UNITED STATES PATENT AND TRADEMARK OFFICE

APPLICATION NO.	FILING DATE	FIRST NAMED INVENTOR	ATTORNEY DOCKET NO.	CONFIRMATION NO.
10/808,395	03/25/2004	Mutsumi Yano	50024-028	5556
7590	03/25/2005		EXAMINER	
McDERMOTT, WILL & EMERY 600 13th Street, N.W. Washington, DC 20005-3096			THOMAS, ERIC W	
			ART UNIT	PAPER NUMBER
			2831

Office Action Summary

DETAILED ACTION

FIG. 6

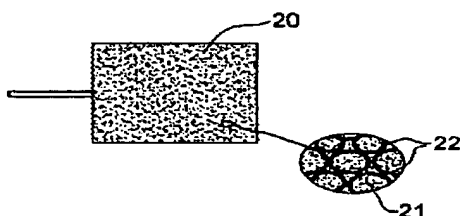
Yoshida et al. disclose in fig. 4, 6, a solid electrolytic capacitor comprising a substrate (13, 21) composed of a porous sinter of niobium particles; a niobium nitride layer (15, 22) formed on the surface of the said niobium particles; and a dielectric layer composed of niobium oxide (upper portion --16) formed on the surface of said niobium nitride layer.
